From: Bland, Chantal [REDACTED]
Sent: 31 August 2017 09:08
To: Planning.Responses
Subject: Response: Planning Consultation M/70/17/HH - 10 Norfolk Way, Elmer, PO22 6JF

Proposal: Two storey side extension & loft conversion.

Site: 10 Norfolk Way, Elmer, PO22 6JF.

M/70/17/HH

Southern Water MapGuide Browser

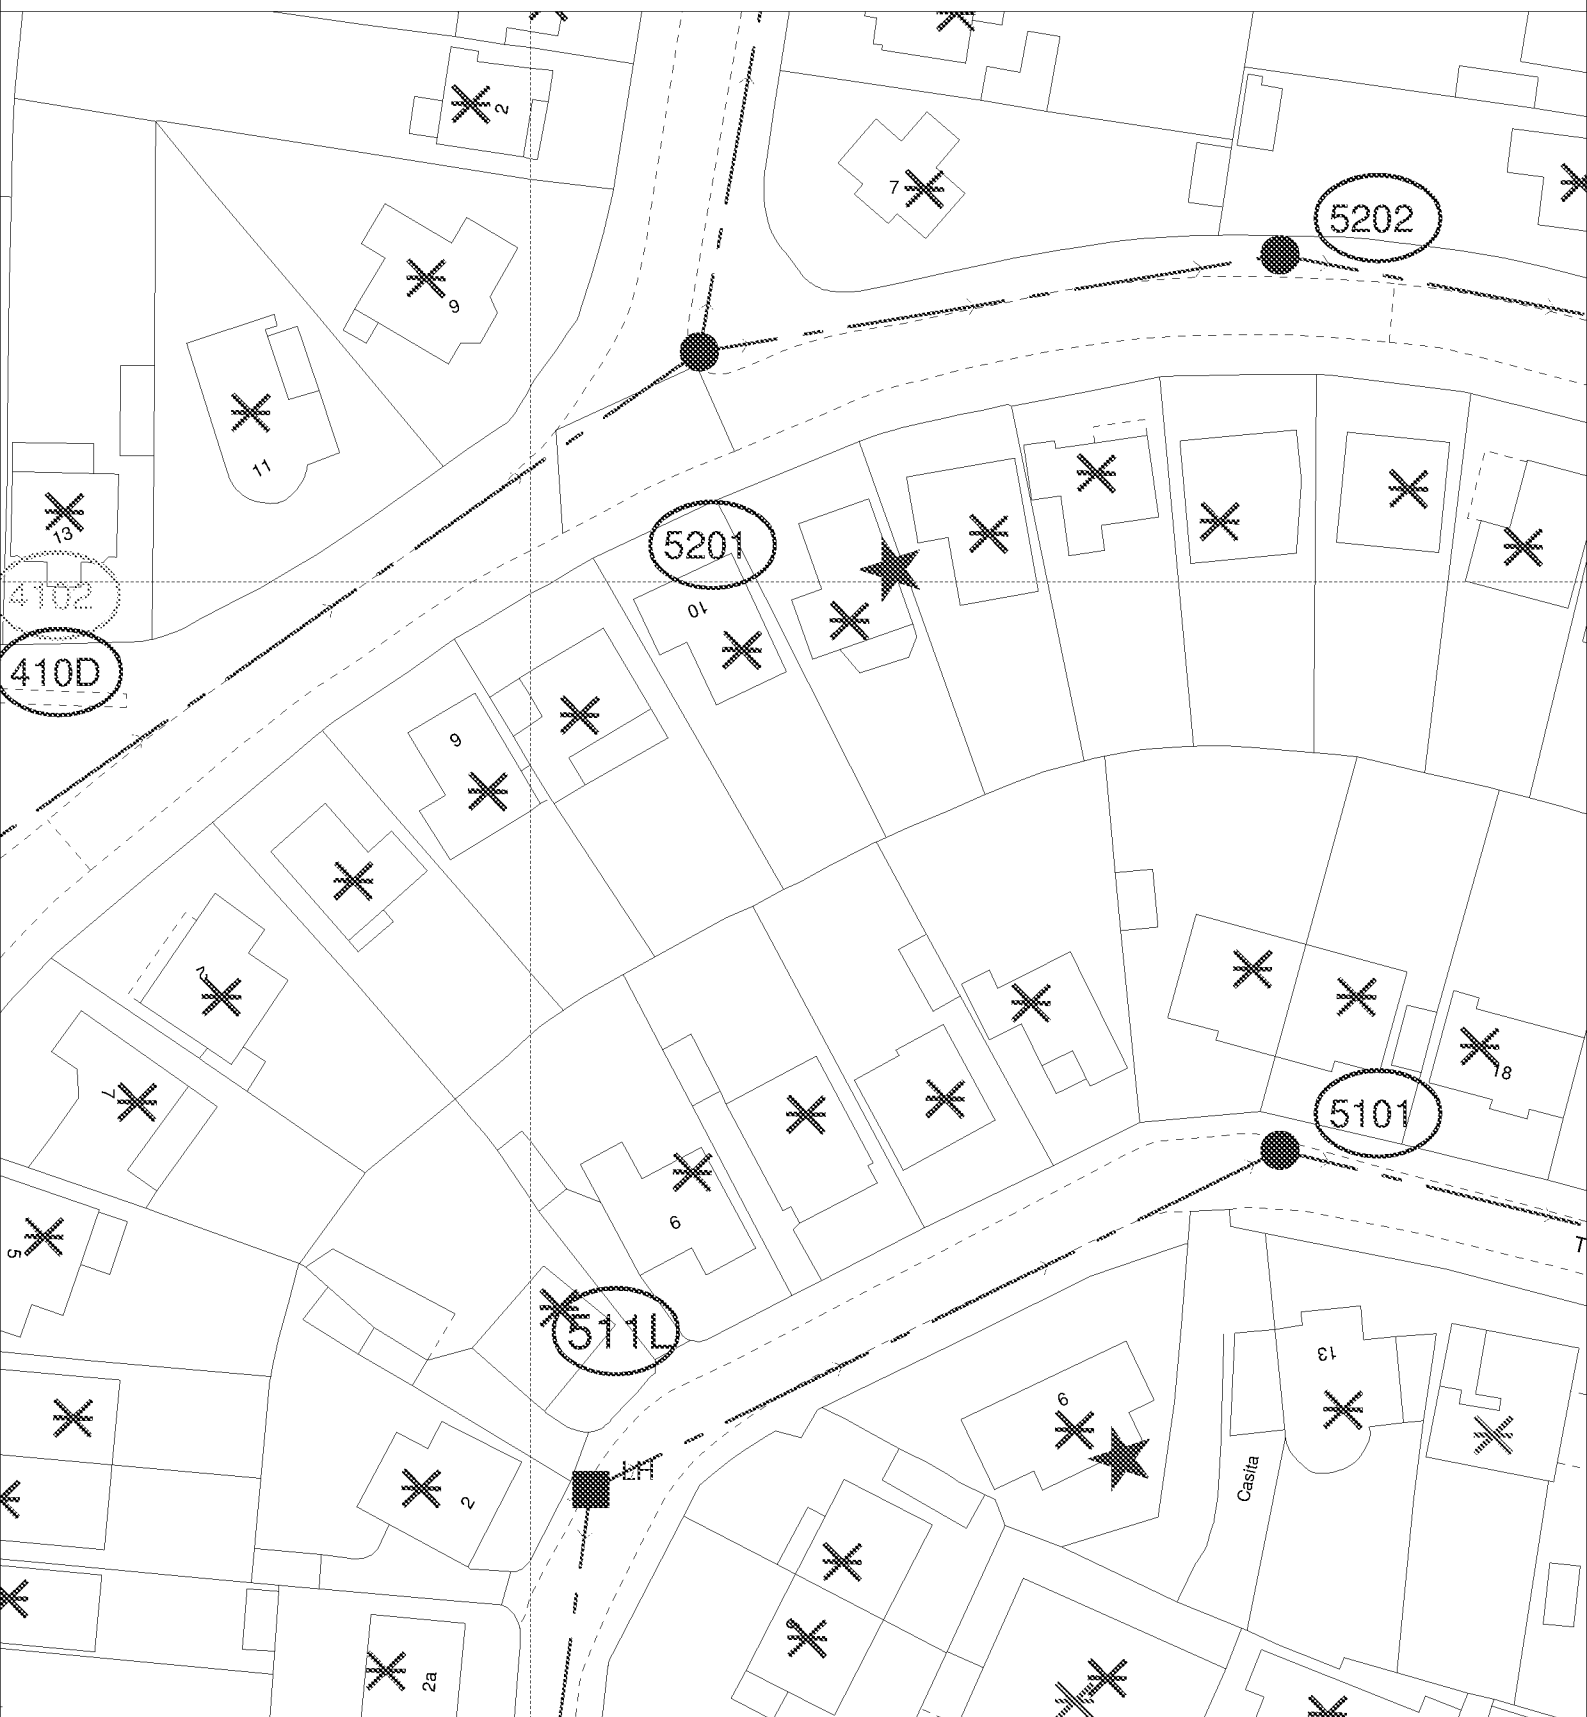
Southern Water requires a formal application for a new connection to the public foul sewer to be made by the applicant or developer.

Our initial investigations indicate that there are no public surface water sewers in the area to serve this development. Alternative means of draining surface water from this development are required. This should not involve disposal to a public foul sewer.

Due to changes in legislation that came in to force on 1st October 2011 regarding the future ownership of sewers it is possible that a sewer now deemed to be public could be crossing the above property. Therefore, should any sewer be found during construction works, an investigation of the sewer will be required to ascertain its condition, the number of properties served, and potential means of access before any further works commence on site.

Due to surface water inundation issues in the Lidsey Catchment "The applicant is advised to adopt, where appropriate, the measures in the table "Practical measures to reduce the potential impacts of development".

Developer should look to protect the public sewerage system from inundation and infiltration, which contribute to flooding in unfavourable conditions.
